RE: Transmittal of Revised Notification of Design Modification to Operable Unit 16 (OU16) Site Improvements Project - Former Diamond Shamrock Painesville Works Site; TER016.600.0005.

## REVISED WORK PLAN – NOTIFICATION OF DESIGN MODIFICATION TO OPERABLE UNIT 16 SITE IMPROVEMENTS PROJECT

**OU16 GRADING AND DRAINAGE  
DESIGN MODIFICATIONS**

**FIGURE 1**  
**STORM SEWER PLAN**  
SEPTEMBER 11, 2009

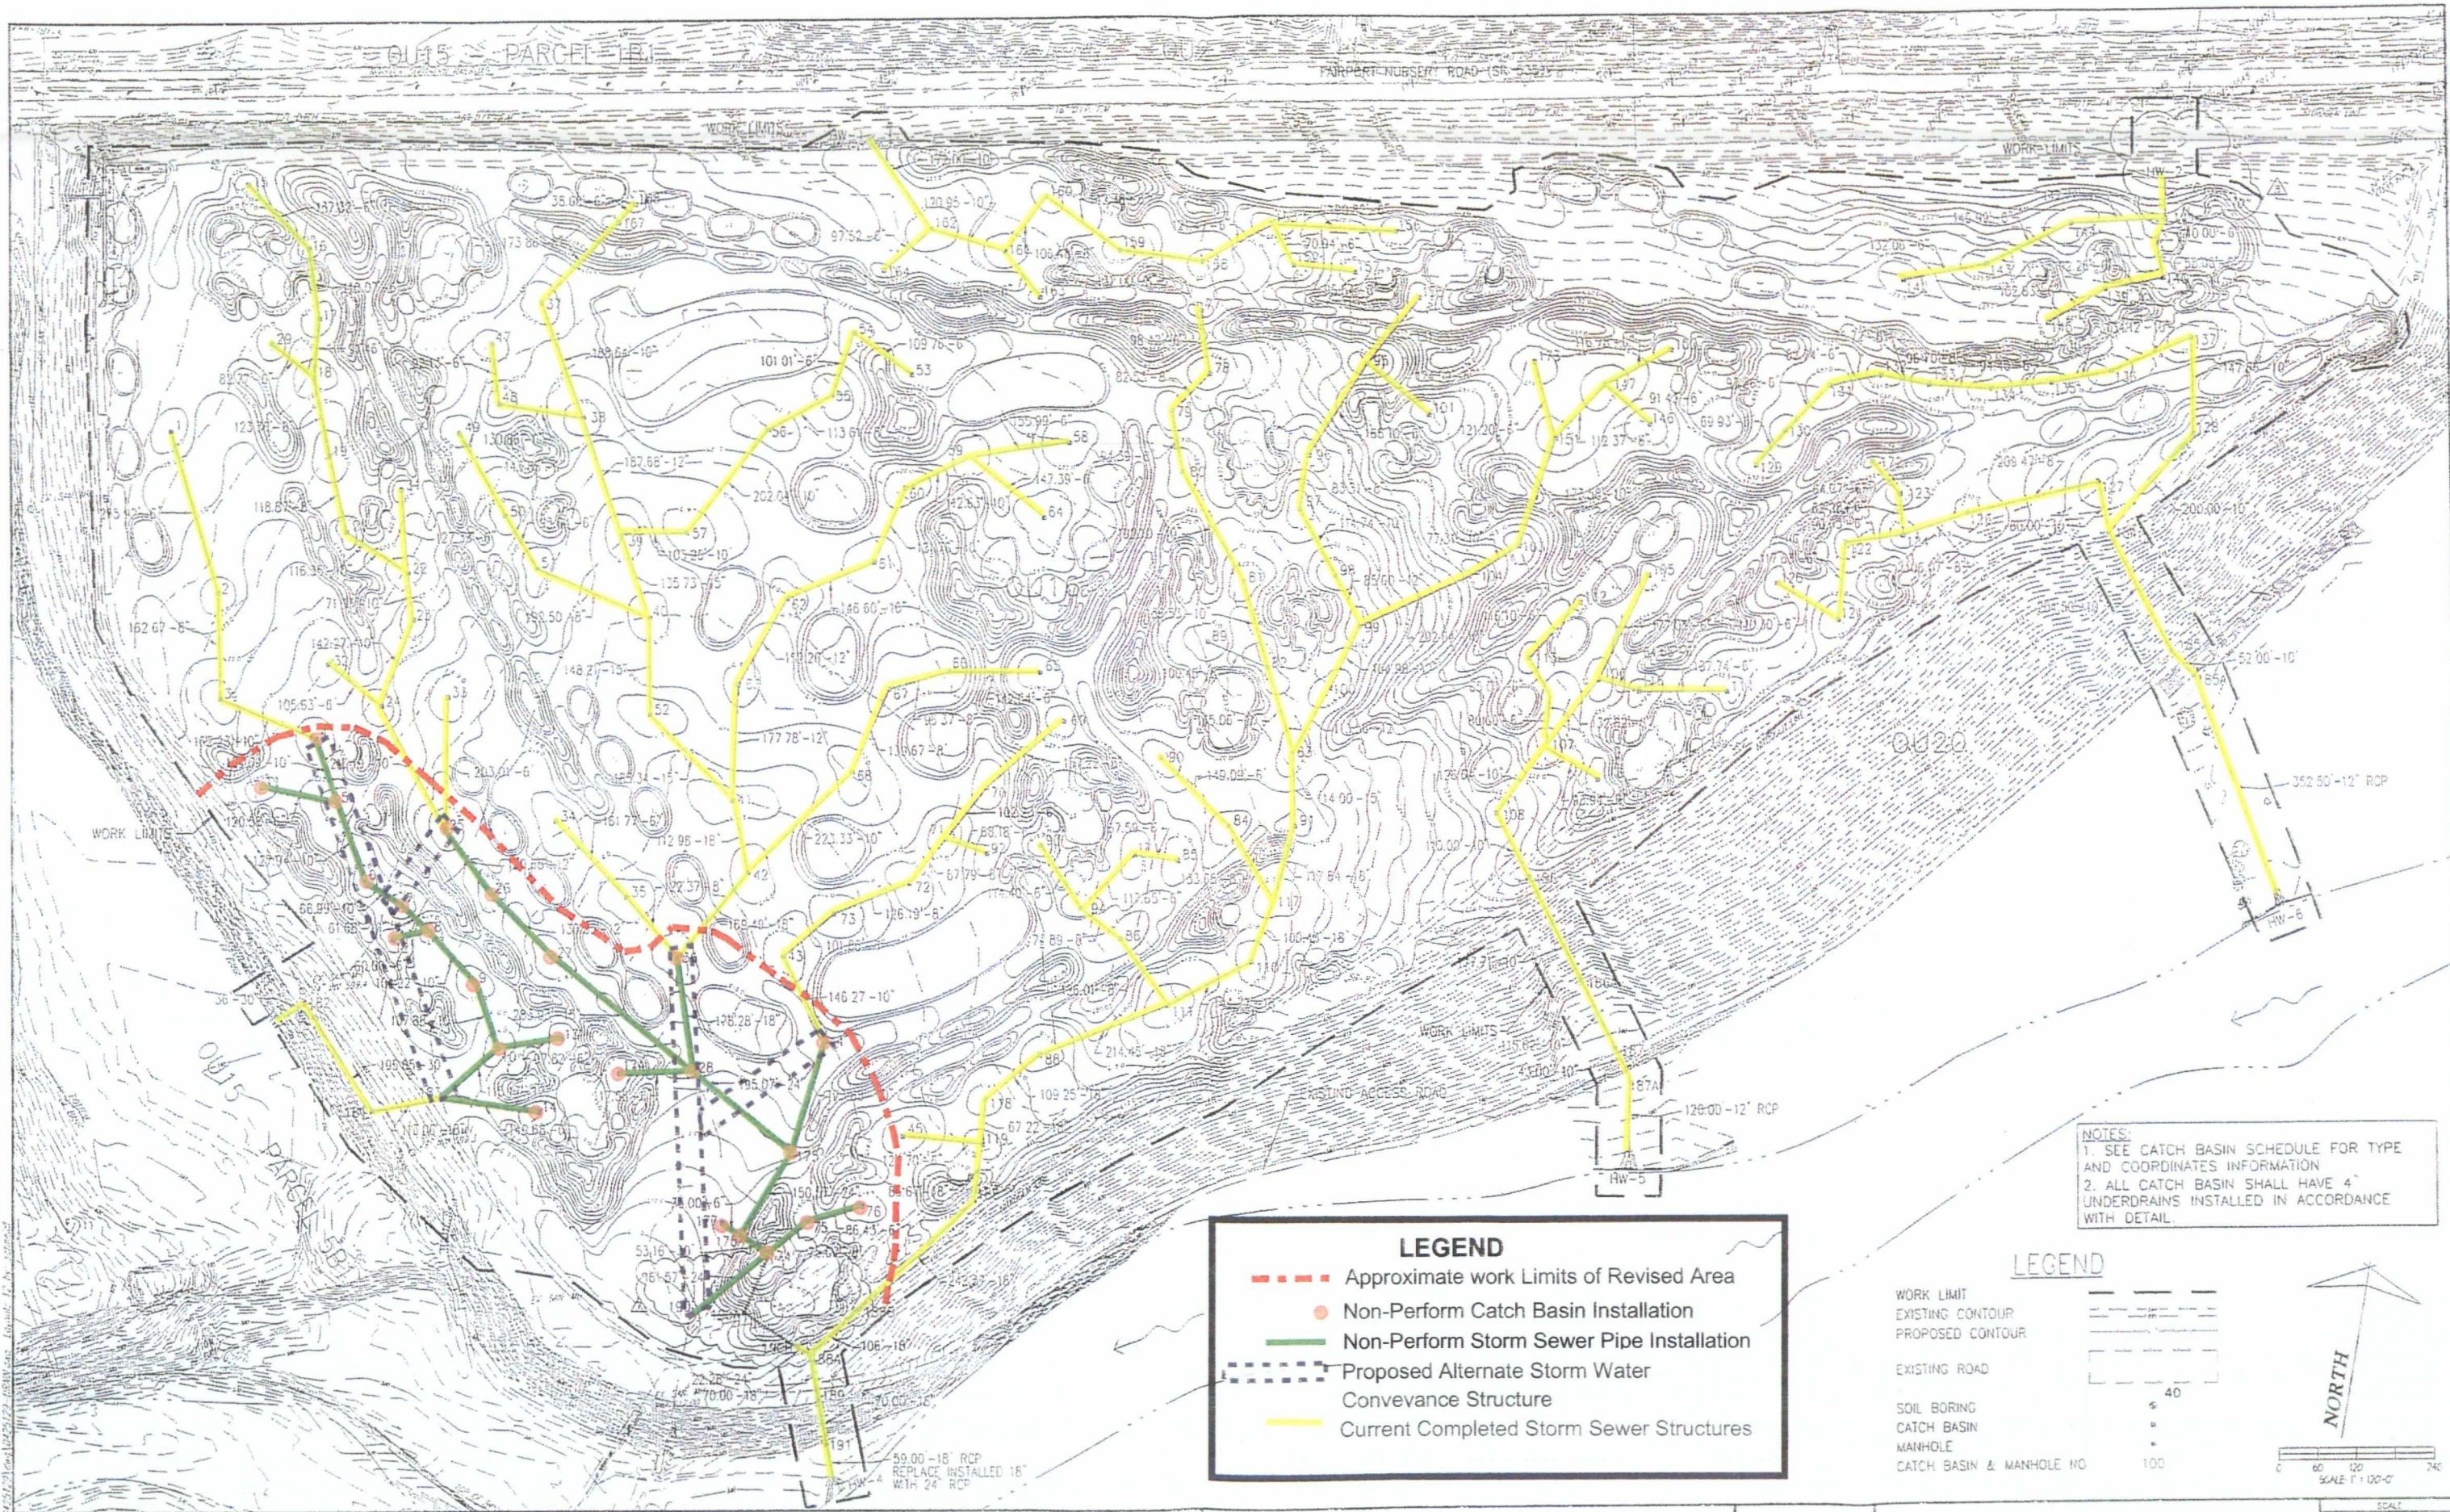
The PRP Group recently reviewed the grading and storm sewer installation design within an approximately 16-acre area located in the southwestern portion of OU16 prior to the completion of these designed improvements. The PRP Group proposes to modify the project design within this area in order to reduce the magnitude of additional fill quantities that otherwise would be required to finish this portion of the work pursuant to the original design. These proposed modifications are consistent with the objectives of the approved IAWP, and the area where changes are proposed is shown on Figure 1.

The modifications proposed in the attached revised grading and drainage plan will result in less storm sewer being installed. Approximately 2,940 feet of storm sewer pipe and as many as 23 catch basin structures will not be installed within the area shown on Figure 1. Storm water conveyance swales will be installed to appropriately manage the storm water in lieu of the planned storm sewers. An engineering analysis was performed and predicted storm water flows and velocities resulting from the upstream storm sewer flows were used to establish the appropriate size and erosion protection in the swales. The foregoing analyses lead to the design of stone erosion protection for the location of each storm sewer outlet into the swales and to the proposed use of Jute Mat to line the swales. Documentation of the analyses is provided in Attachment A of this work plan. As a result of the proposed re-design, the storm water conveyance swales will provide the same capacity for storm water flow as the uninstalled storm sewer. Implementing these revised project requirements also will result in approximately 47,000 fewer cubic yards of clean soil fill.

FIGURE 3

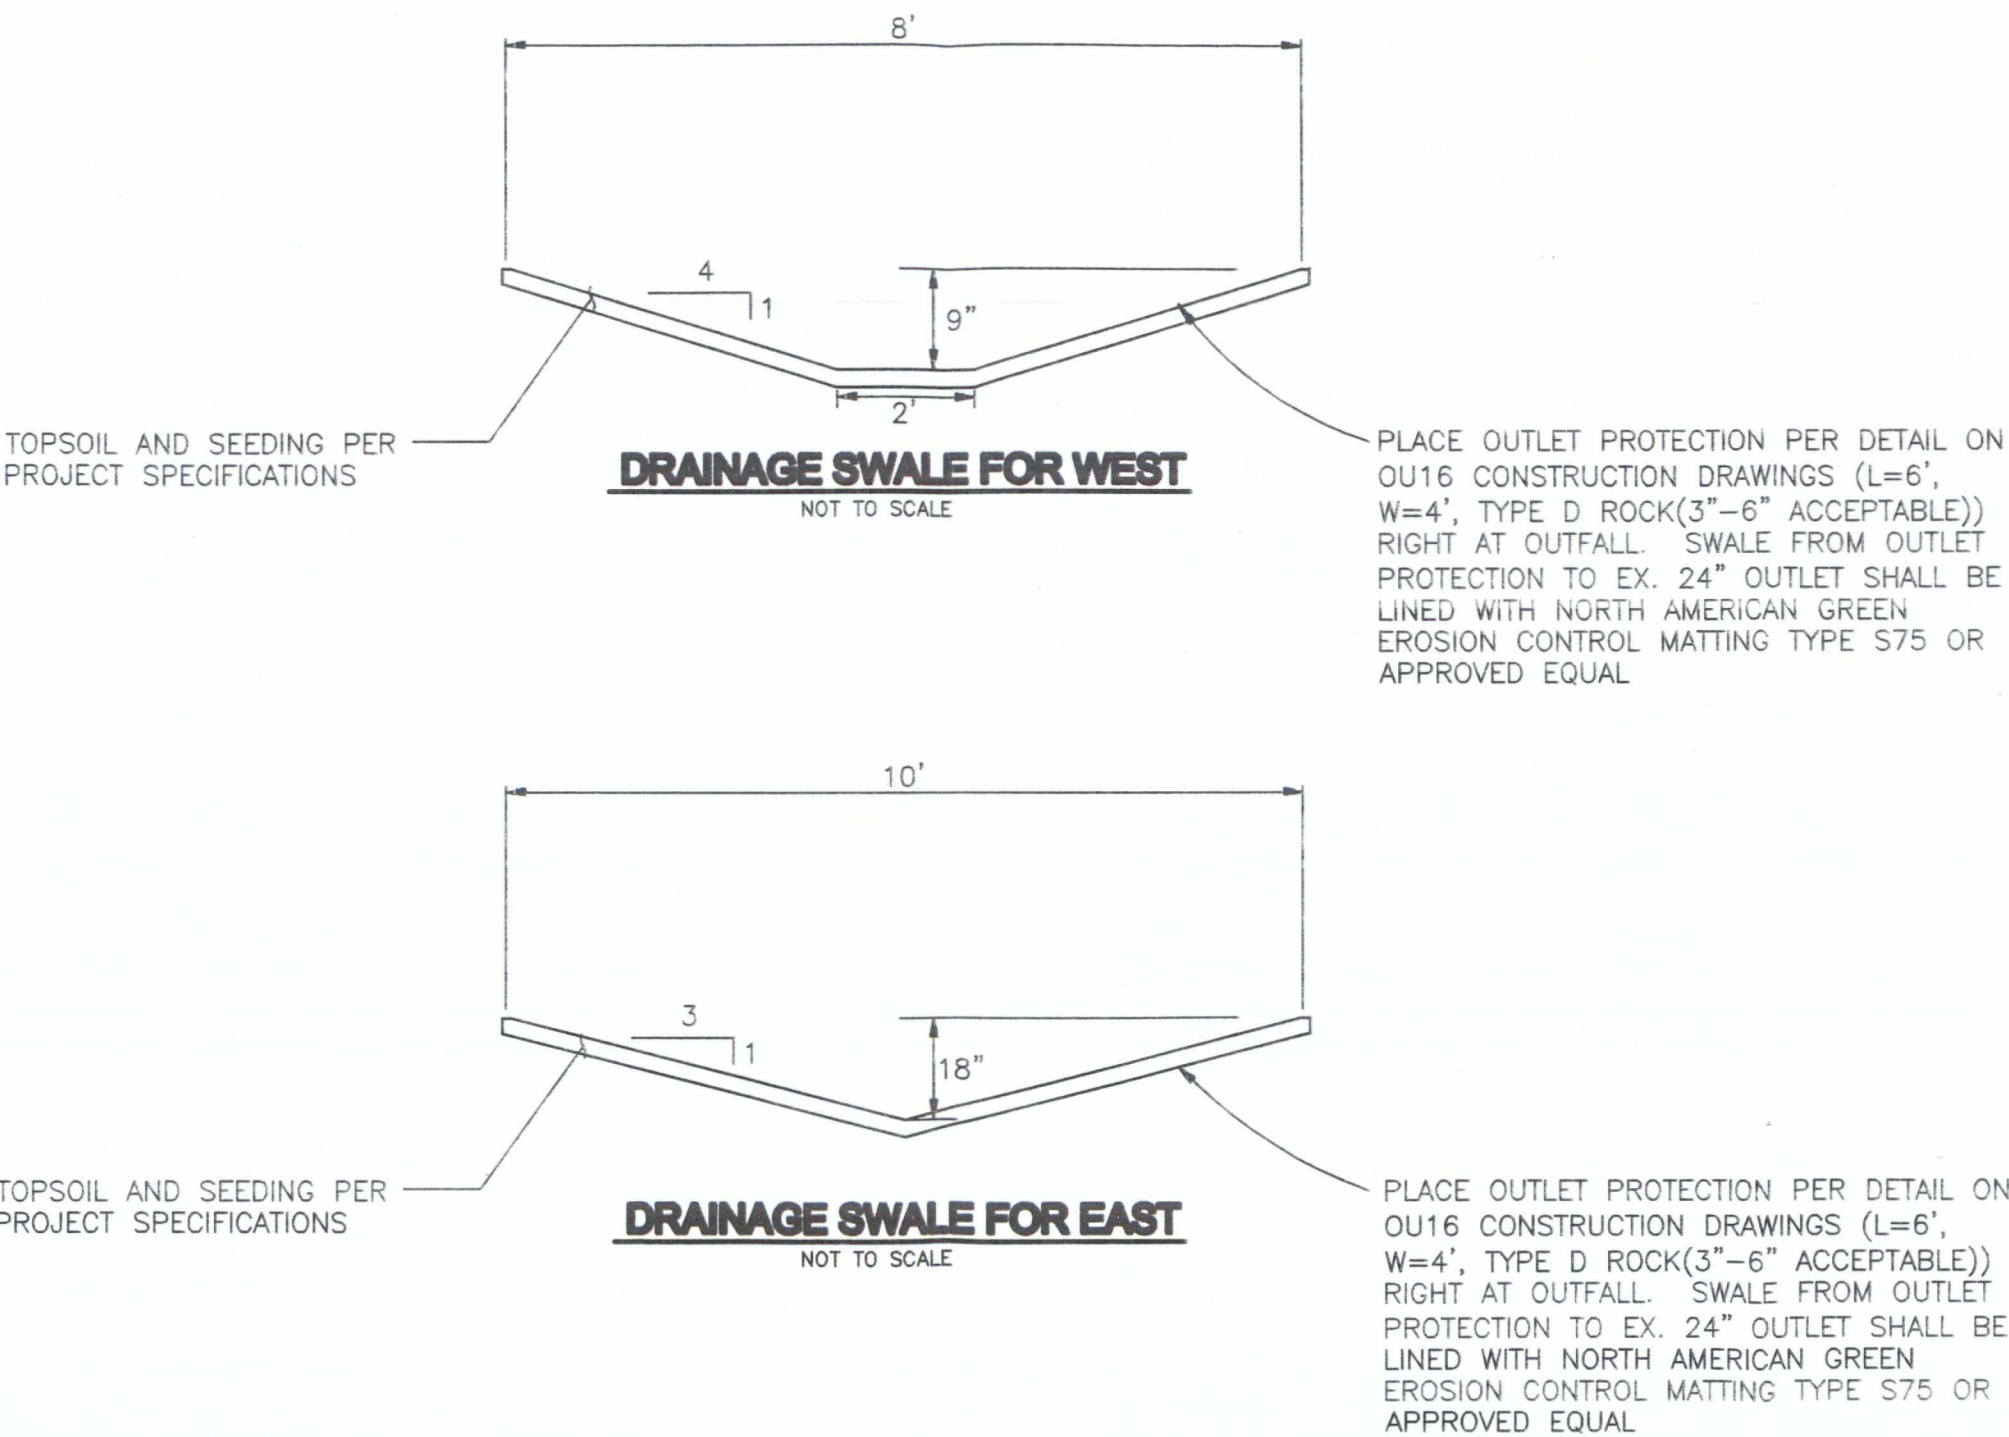
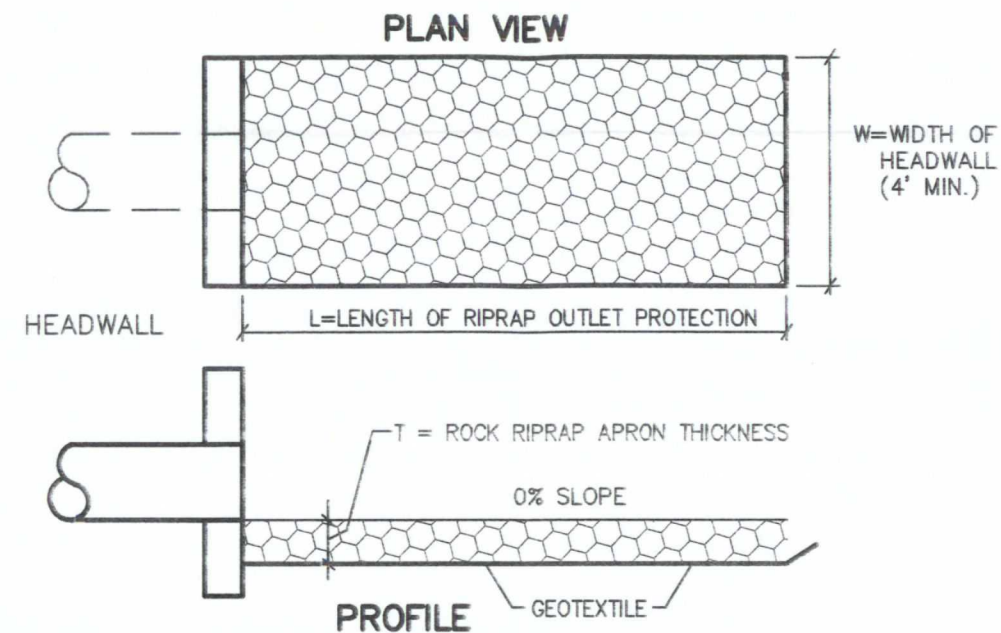
A revised grading and drainage plan was developed based on those criteria. Figure 2 shows the proposed modifications. A comparison of Figure 1 and Figure 2 shows that less soil will be embanked based on the proposed modifications. The revised grading and drainage design also requires some storm sewer pipes originally intended to be covered by the additional golf course fill material to be replaced with storm water conveyance swales in the proposed design. Additional details of the storm water conveyance swales are shown in Figure 3 and Figure 4.

The recommended S75 Erosion Control Blanket will provide stability for up to 5 fps velocities and up to 1.55 psf shear. In both cases, use of this material will provide protection to limit scouring. The functional longevity of the Erosion Control Blanket is 12 months. Established vegetation in the channel will then provided stability for 1.00 psf of shear, protecting both channels from scouring.

**FIGURE 2**

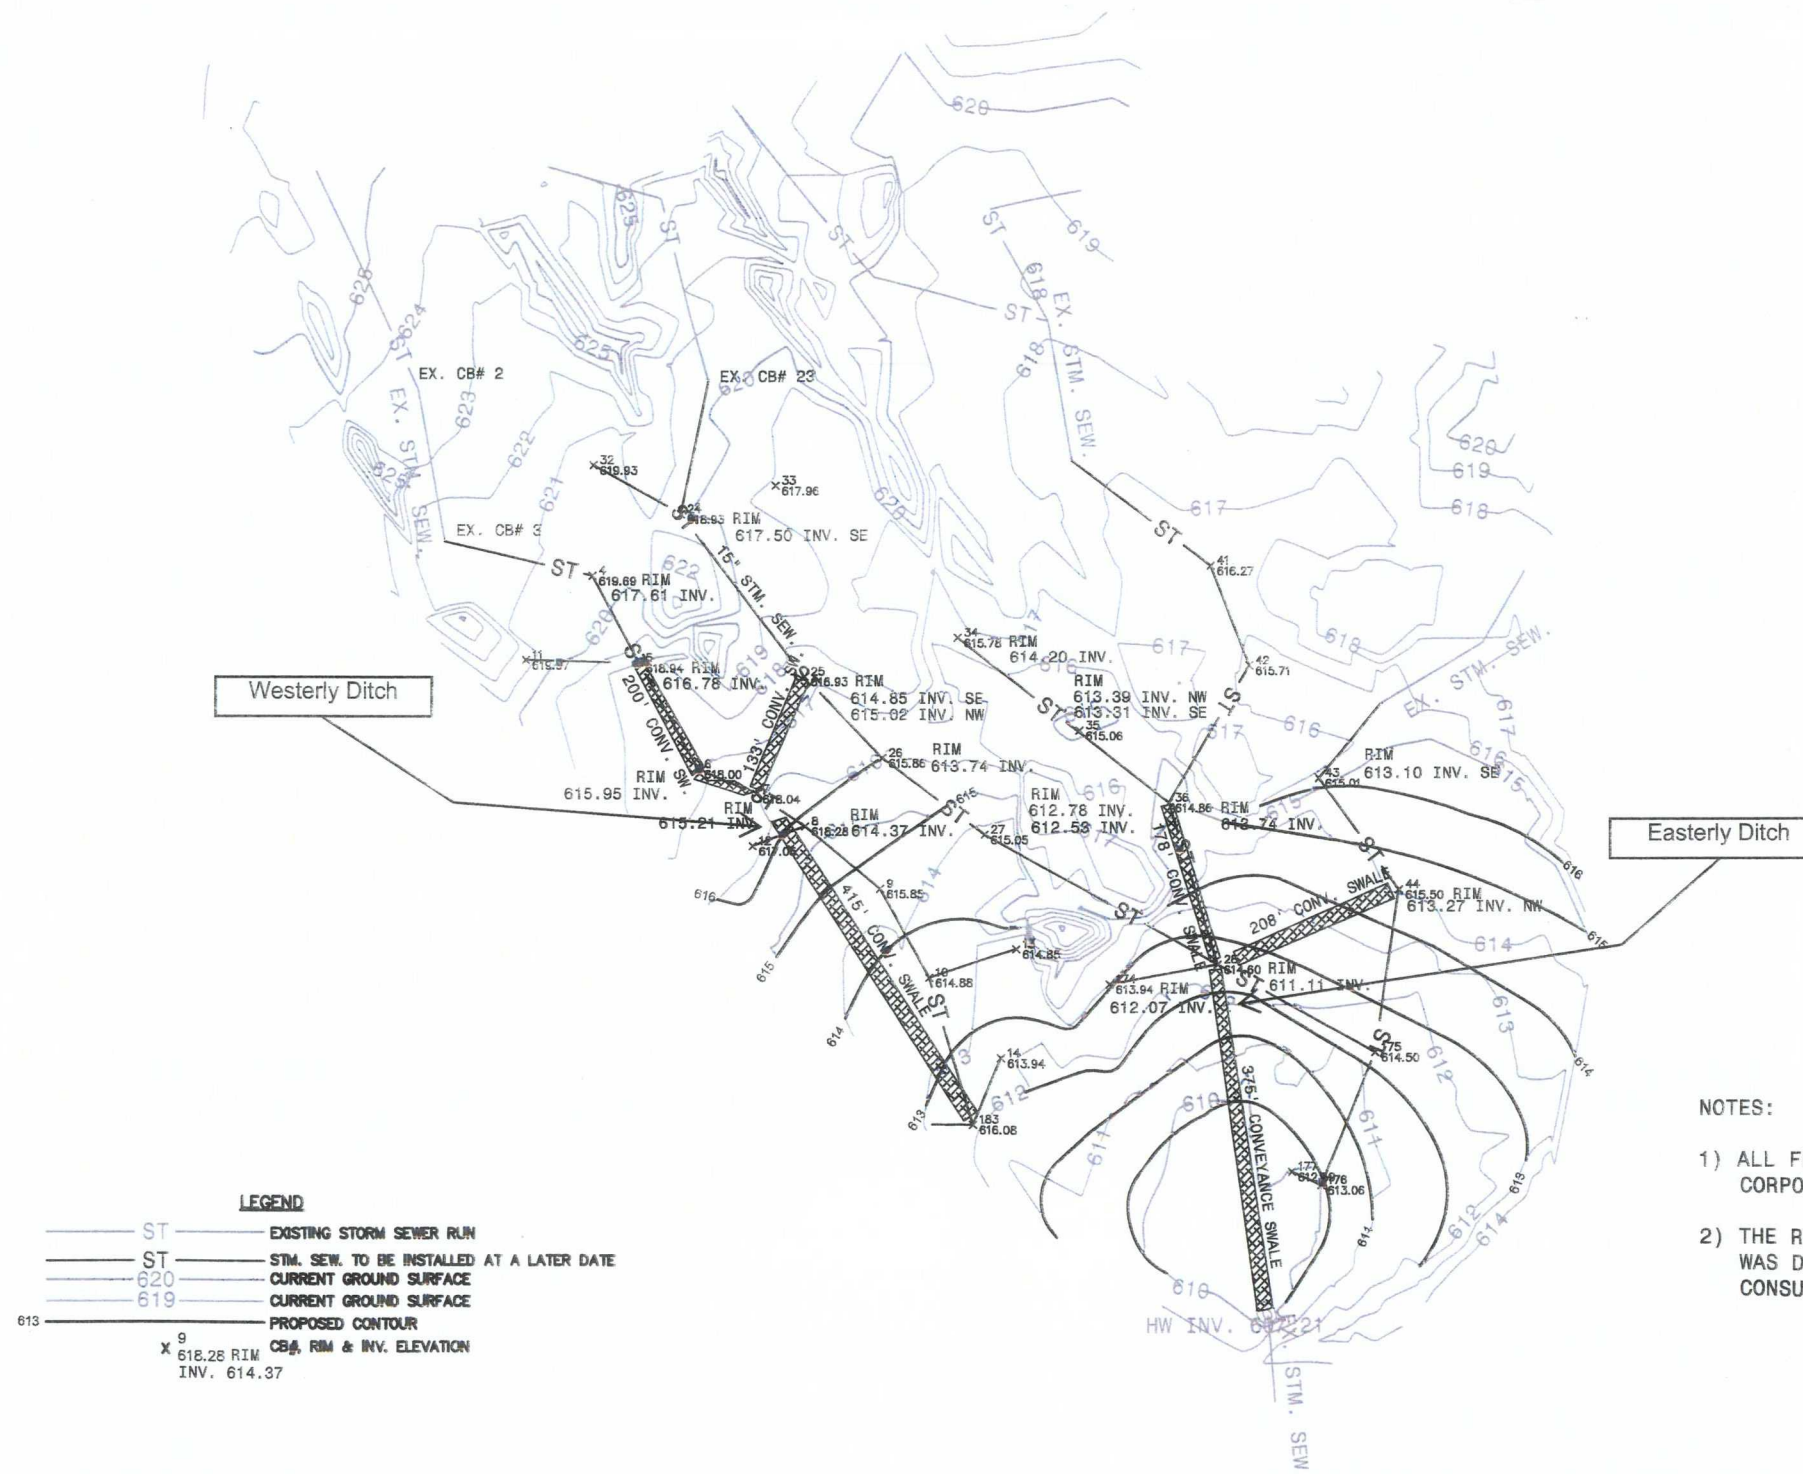
See the drainage swale recommended sections that include material callouts. Ditch Analysis sheets for the three storm events and a summary chart of that data is also provided. Figure 2 indicates locations of the east and west channels.
